5.1: Parks & Open Space Standards

We are proposing clarification of Section 5 in the PD, addressing open space and tree-save (trees that cannot be removed). "Section 5.1: Open Space, B" of the approved PD states that "surpluses in the minimum area of any individual open space may be applied to deficiencies in other required open spaces." We have proposed the addition of language in "Section 5.2: Trees, D" to apply this same concept to tree-save areas, allowing for surpluses in any individual tree-save area to be applied to deficiencies in other required tree-save areas, so long as the total acreage of tree-save is maintained.

FIGURE 5.1
OPEN SPACE PLAN

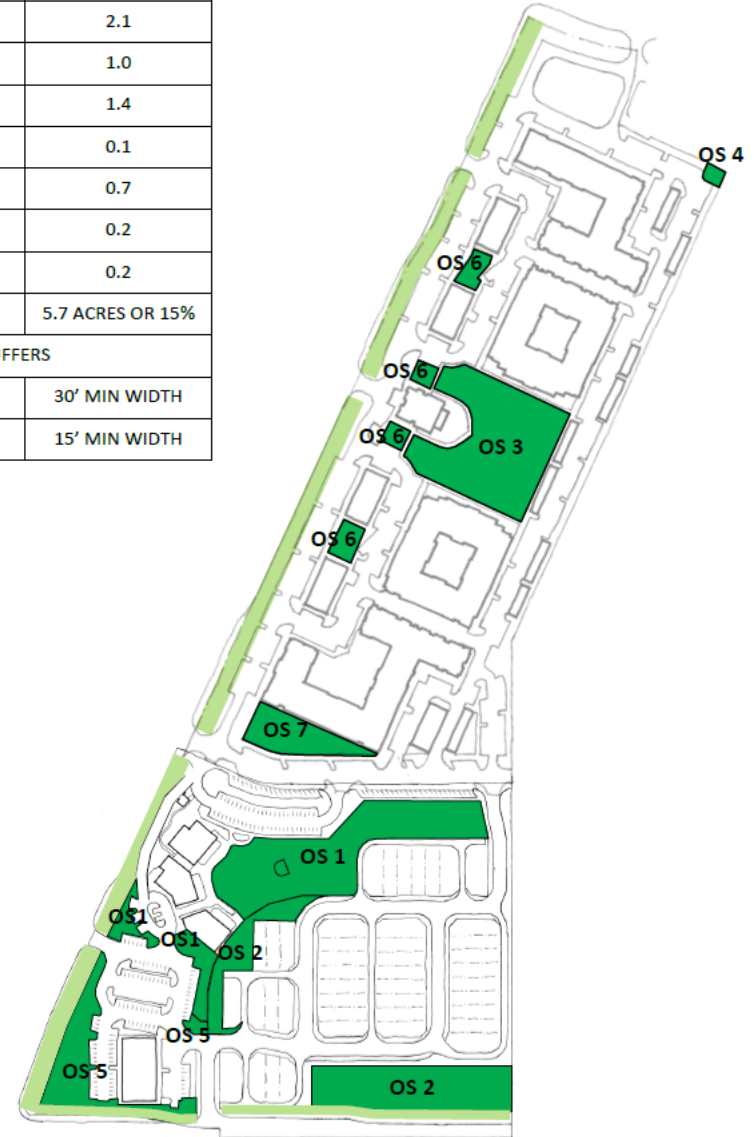
The approved open space standards require OS 2 to have a tree-save area of at least 75% of the joint open space (0.75 acres) and OS 5 to have a tree-save area covering at least 60% of the open space (0.42 acres) for a total of 1.17 acres of tree-save area.

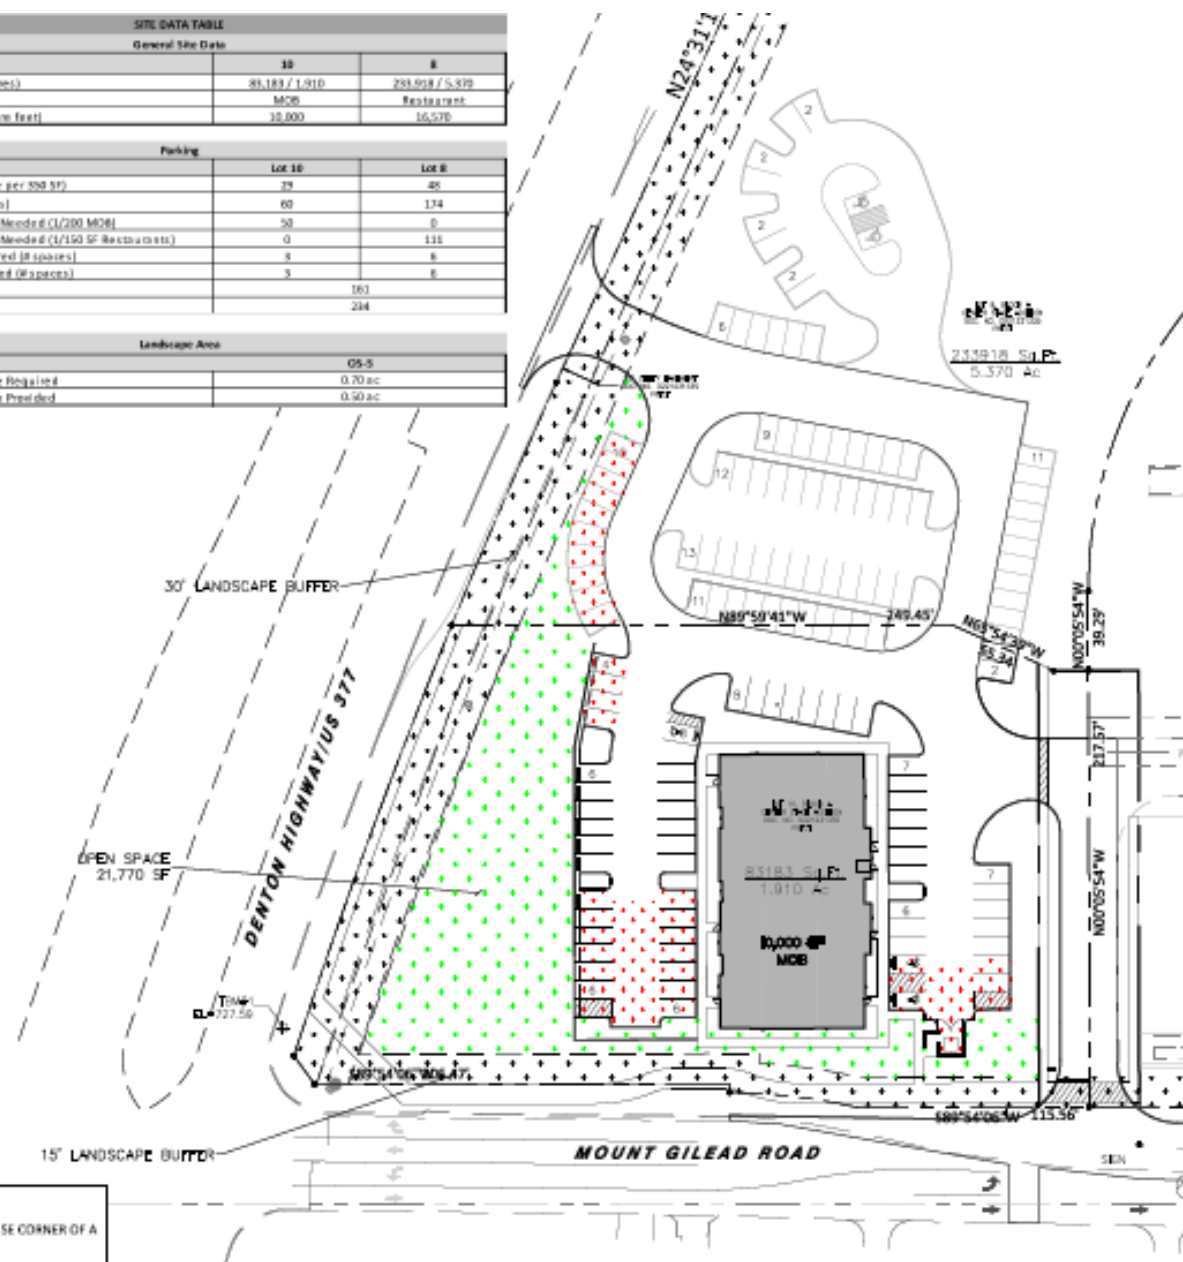
Due to fire truck access and parking needs both for the medical office building and for the 3 restaurants, while maintaining as much open space and tree save as possible, this configuration for the medical office building is the most ideal and came after multiple iterations in collaboration with City staff.

The medical office building, located in OS 5, in this configuration, can provide 0.50 acres of open space and 0.30 acres of tree-save, creating shortfalls of 0.20 acres of open space and 0.12 acres of tree-save area.

In order to compensate for this shortfall, the PD allows for surpluses in open space in any individual open space to be applied to deficiencies in others, so OS 2 (the single-family home lot) can accommodate. The intent is for OS 2 to also accommodate the shortfall in OS 5's tree-save area.

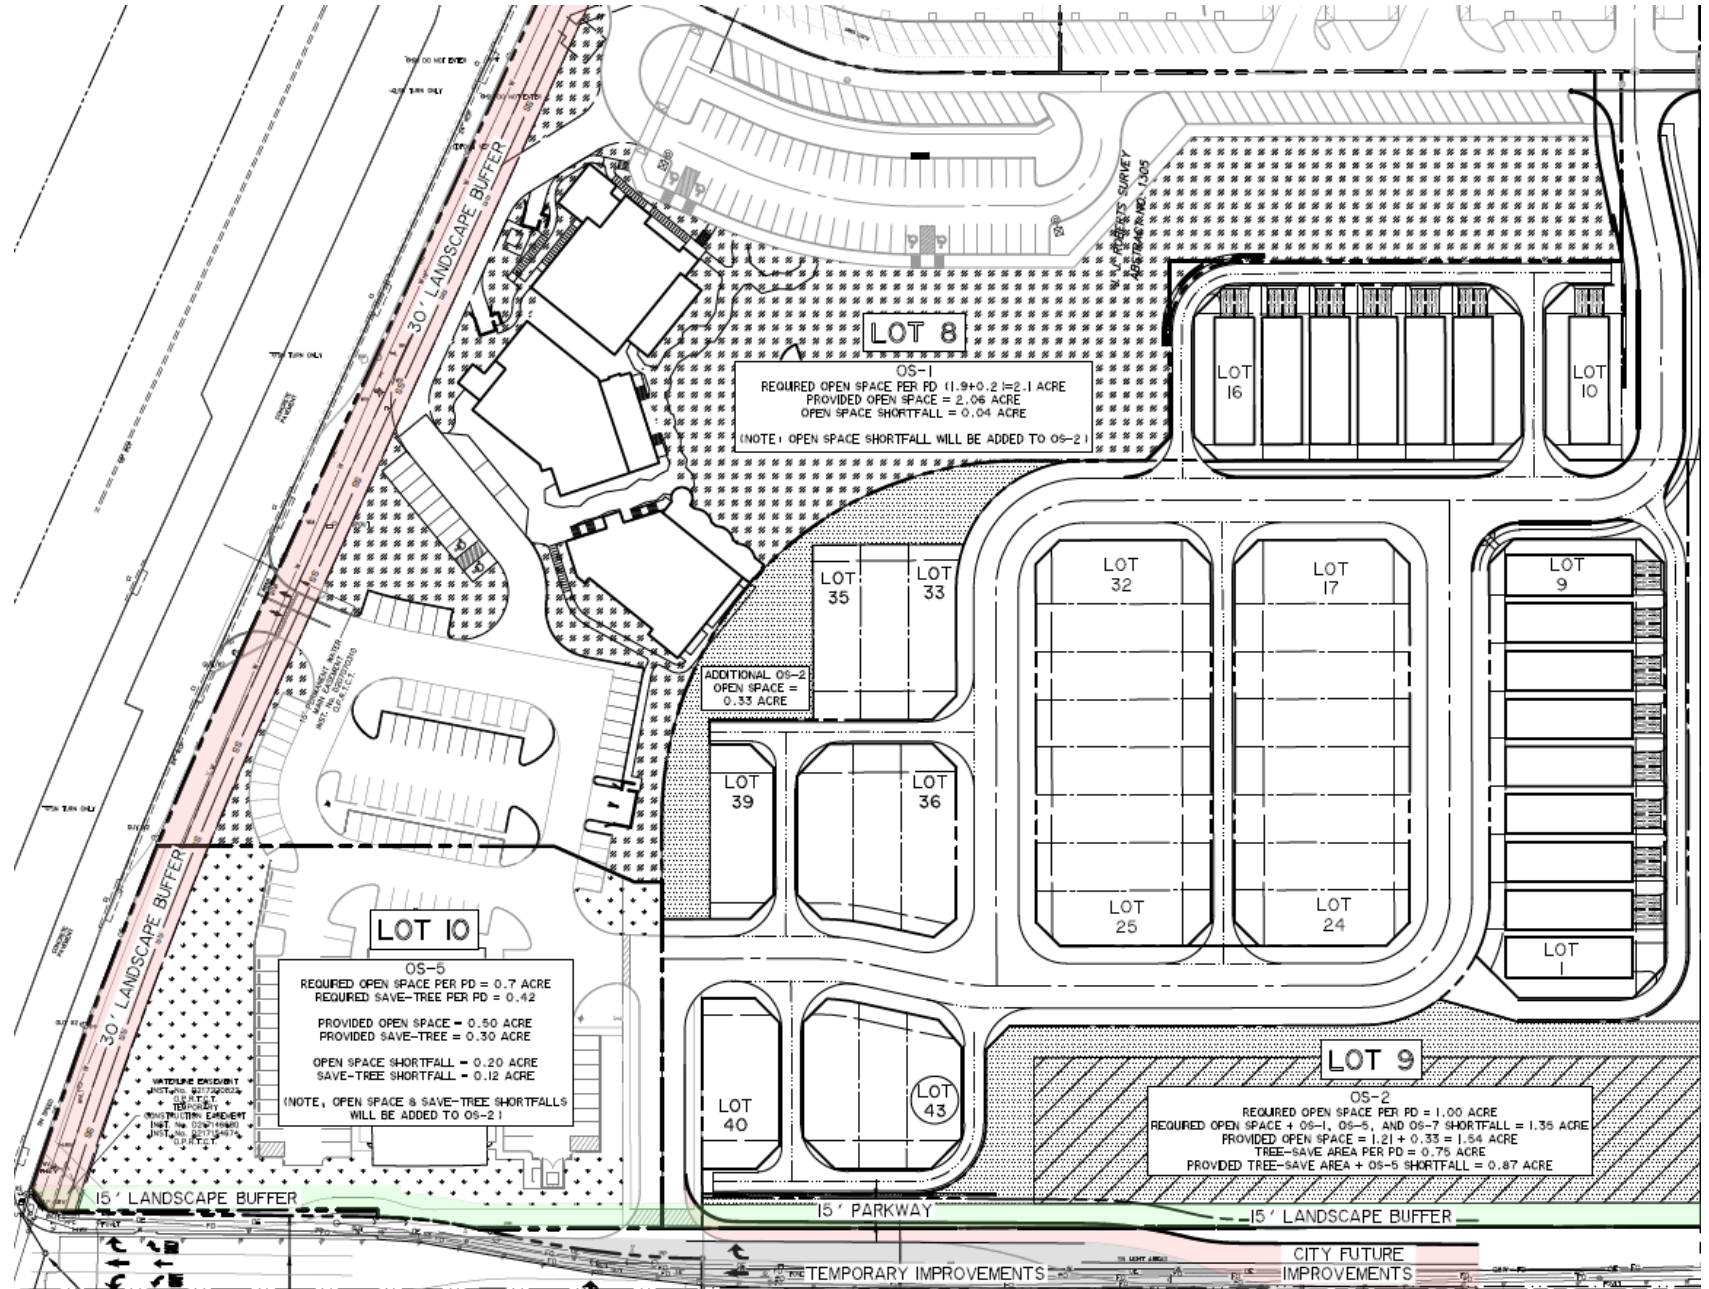
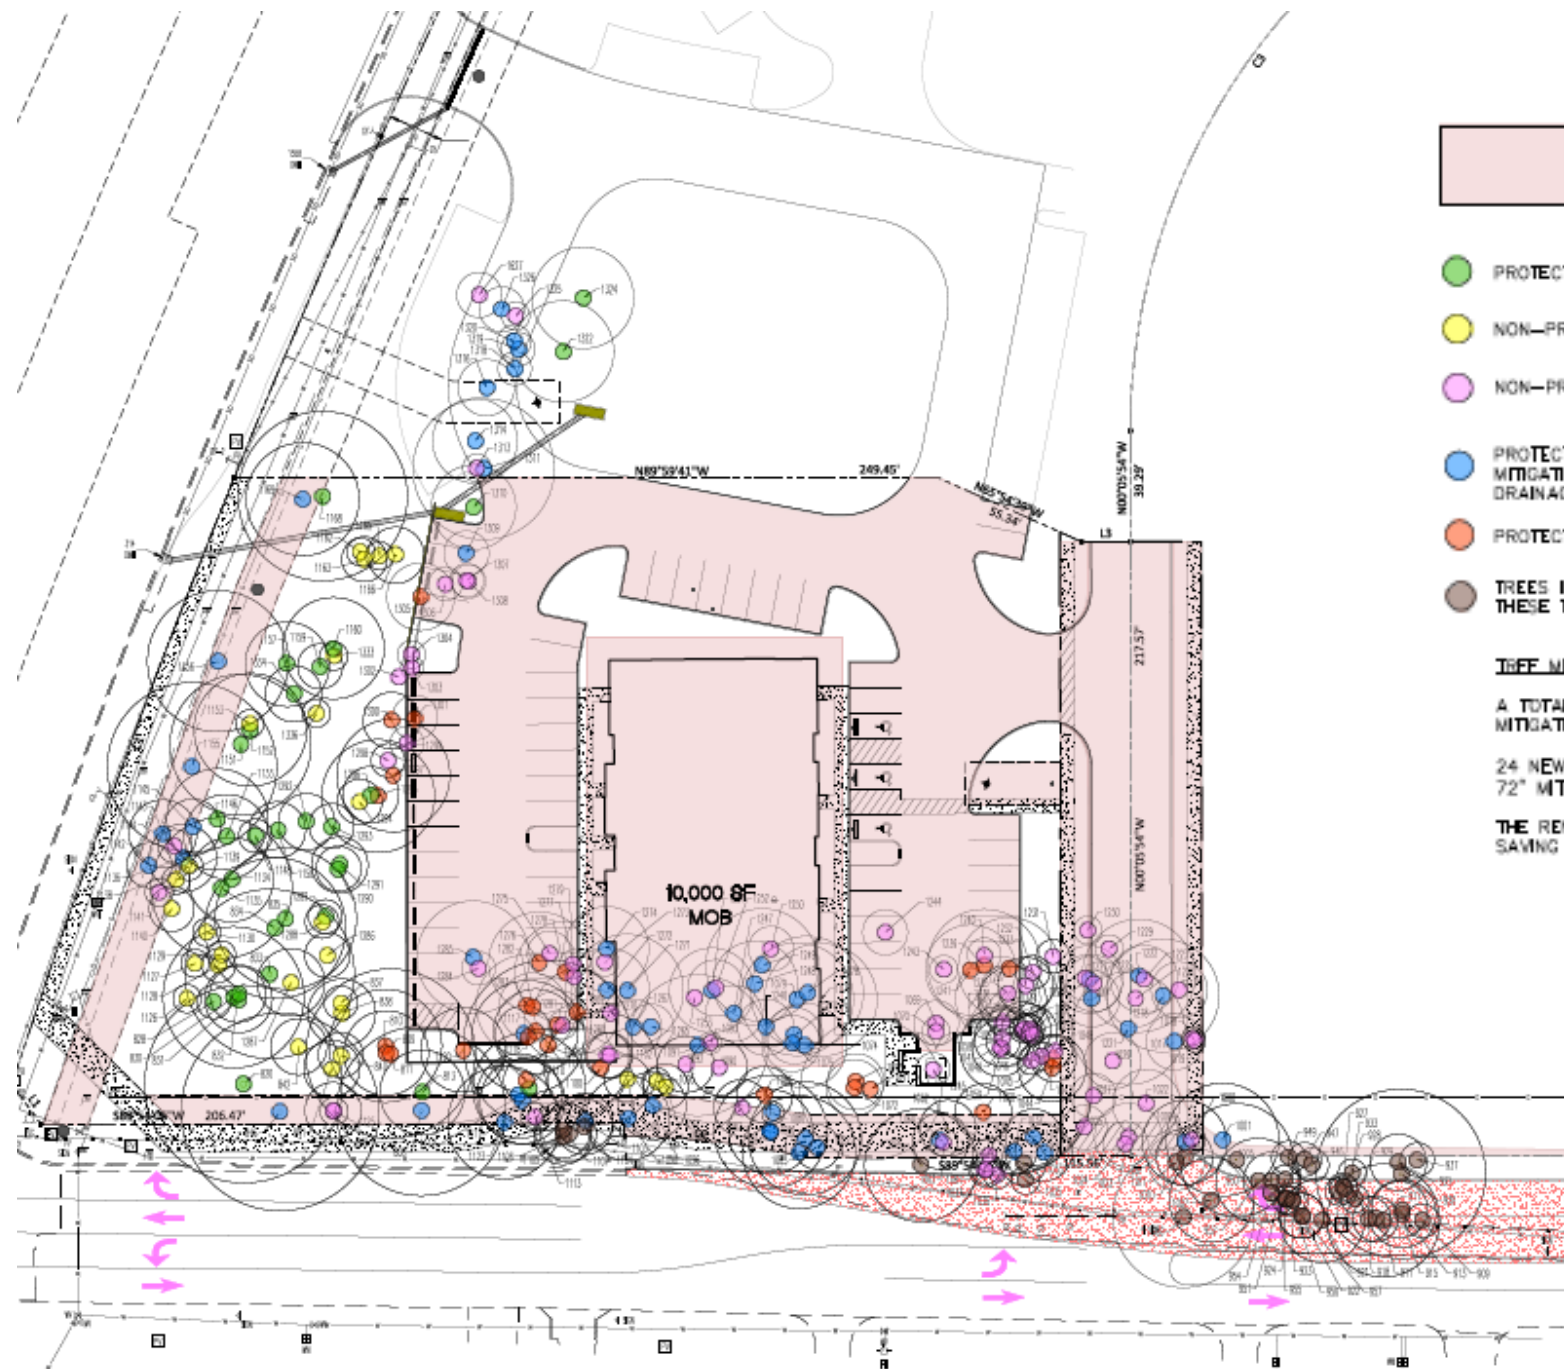
OS 2 (within Lot 9) is required by the PD to have at least 1.0 acre of open space and 0.75 acres of tree-save area. In order to accommodate open space shortfalls in OS 5 (Lot 10) of 0.20 acres, in OS 1 (Lot 8) of 0.04 acres and in OS 7 (Lot 7, north of Lot 8) of 0.11 acres, the new required open space for OS 2 is 1.35 acres. In order to accommodate the tree-save shortfall in OS 5 of 0.12 acres, the new required tree-save area in OS 2 is 0.87 acres. This plan shows 1.54 acres of open space and 0.87 acres of tree-save area provided in OS 2, arriving at the same required total of 1.17 acres.

A TOTAL OF 198 CALIPER INCHES ARE REQUIRED TO BE MITIGATED. FOLLOWING IS HOW MITIGATION WILL BE ACHIEVED:

24 NEW 3" CALIPER TREES WILL BE PLANTED.
72" MITIGATION.

THE REMAINING REQUIRED MITIGATION WILL BE ACHIEVED BY SAVING EXISTING TREES.
